Amendments to the Drawings:

REMARKS

Irie – Figure 2 (annotated)

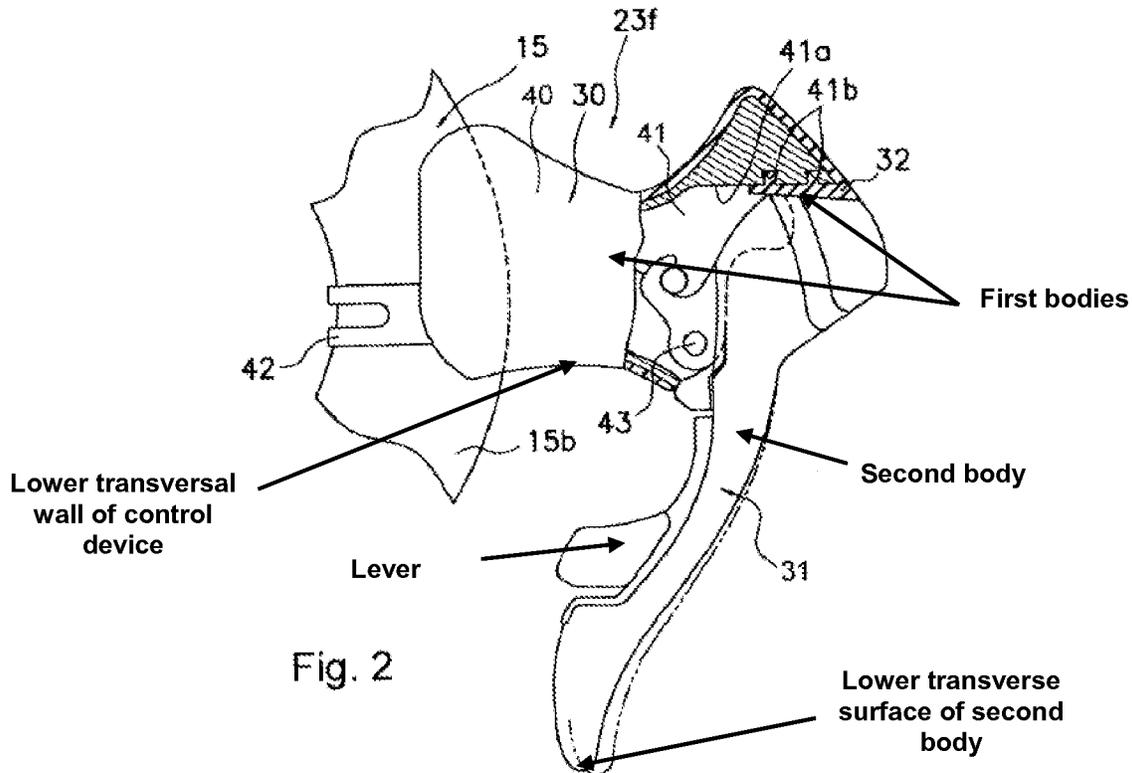
As shown in the annotated Figure below, Irie fails to disclose a lower transversal wall of the control device is partially defined by the lower transverse surface of the second body. The Examiner identified the lever member (31) as the second body. In contrast to the independent claims, Irie's lower transversal wall of the control device is entirely defined by the lower transverse surface of the first body, i.e. the lower transverse surface of the bracket (30). The lower transverse surface of Irie's second body (lever member (31)) does not define any portion of the lower transversal wall of the control device. The Action included annotated cross-sectional views of the Irie's

Figures but failed to identify the lower transversal wall of the control device. Irie's lower transversal wall of the control device and lower transverse surface of the second body are indicated below in annotated Figure 2. Irie fails to disclose a lower transversal wall of the control device that is at least partially defined by the lower transverse surface of the second body as recited by claims 1, 31, and 39. Withdrawal of the section 102 rejection of claims 1, 31, and 39 is respectfully requested.

Shimano – Figure 1 (annotated)

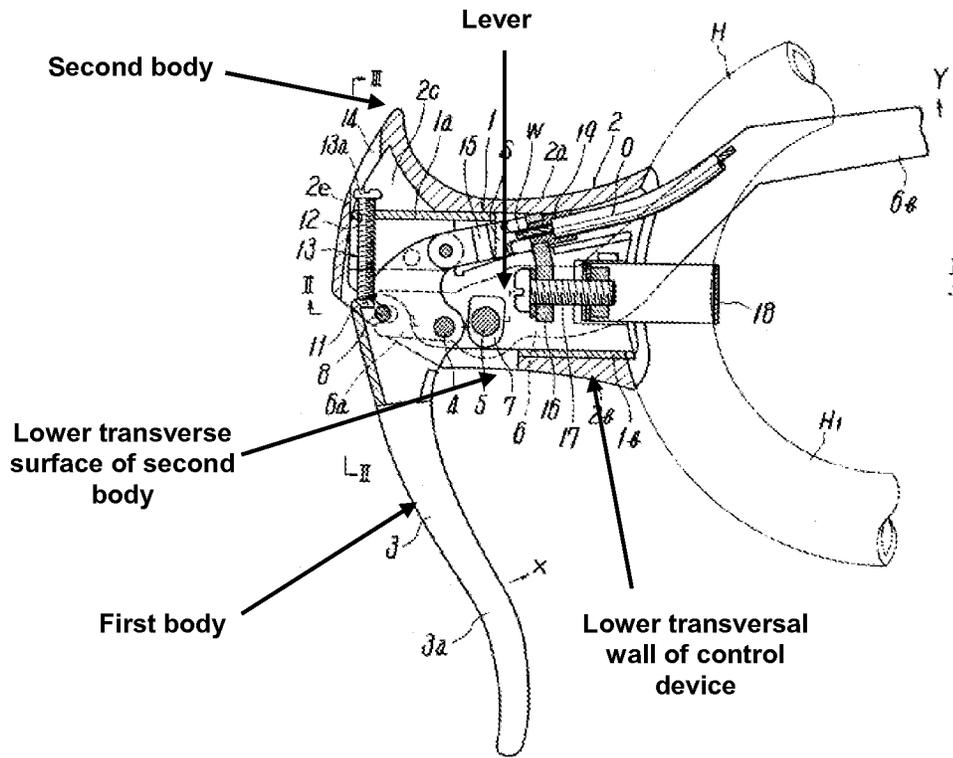
The Examiner cited Shimano's first lever (3) as the first body; a second lever (6) as the lever; and a cover (2) as the second body. The cover (2) extends around the entire bracket member (1). The first lever (3) extends along a bent portion of the handlebar and the second lever (6) extends along a straight portion of the handlebar. The second lever (6) projects from a side wall (1c) of the bracket member (1).

Shimano's first body (first lever (3)) does not include a rear surface that is shaped to be associated with a bicycle handlebar as recited by the independent claims. The first lever (3) has an end housed within the bracket member (1); Shimano's first body (first lever (3)) does not include an upper transverse surface that defines an upper transversal wall of the control device as recited by the independent claims. Shimano fails to disclose the lever (second lever (6)) is hinged to the front portion of the first body (first lever (3)) as recited by the independent claims.
